Access Compliance Report
Public Rights-of-Way
(Curb Ramps)

Intersection ID: 9530	Main Street: MCBRIDE_ST	Cross Street: THE_PLAZA	Location:	N
ADA ID: 90897E7C37CC	Ramp Type: PerpDiag	Initial Pass/Fail: Pass	Overall Compliance: No	Severity Score: 27.75

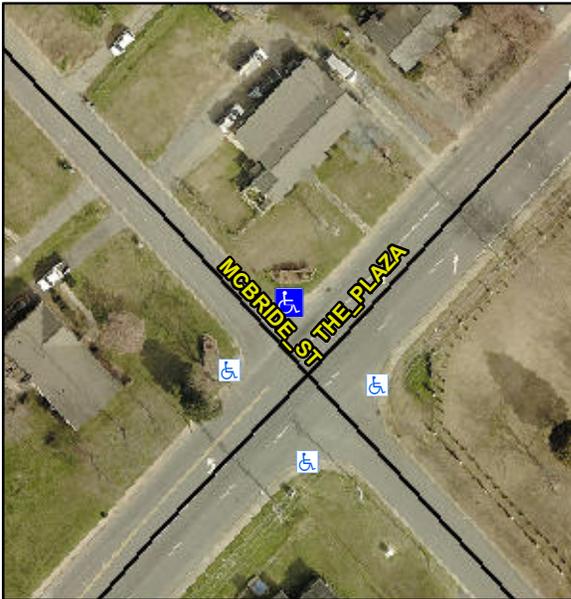
Not Found, R304.5.3, R304.2.1, R304.2.2-Perp, R304.3.2-Para, R305.1.4, R305.2, R302.7, R302.7.2

Compliance	Description	Data	Compliance	Description	Data
N/A	Ramp Length (in)	55.0	Yes	Ramp Slope (%)	7.7
Yes	Ramp Width (in)	54.0	No	Ramp XSlope (%)	2.8
N/A	Flare Type LT	Sloped	N/A	Flare Type RT	N/A
N/A	Flare Slope LT (%)	4.1	Yes	Flare Slope RT (%)	9.8
N/A	Flare Traversable LT?	No	N/A	Flare Traversable RT?	Yes
No	Landing Length (in)	N/A	Yes	DWS Provided?	Yes
No	Landing Width (in)	N/A	Yes	DWS Contrast?	Yes
No	Landing Slope (%)	N/A	Yes	DWS Length (in)	24.0
No	Landing X Slope (%)	N/A	No	DWS Full Width?	No
N/A	Landing Curb? (Y/N)	No	No	DWS Offset (in)	4.0
N/A	Shared Landing?	N/A			
No	Gutter Ponding?	Yes	Yes	Gutter Slope (%)	4.5
No	Gutter Lip Ht (in)	1.0	Yes	Gutter X Slope (%)	1.6
N/A	Painted X Walk1?	No	N/A	Painted X Walk2?	No
	X Walk 1 Direction	To SW		X Walk 2 Direction	To SE
N/A	X Walk 1 Width (in)	N/A	N/A	X Walk 2 Width (in)	N/A
	X Walk 1 Slope (%)	1.6		X Walk 2 Slope (%)	2.5
	X Walk 1 X Slope (%)	0.4		X Walk 2 X Slope (%)	0.8

Remove & Replace Curb Ramp With Two New Directional Ramps or Equivalent.
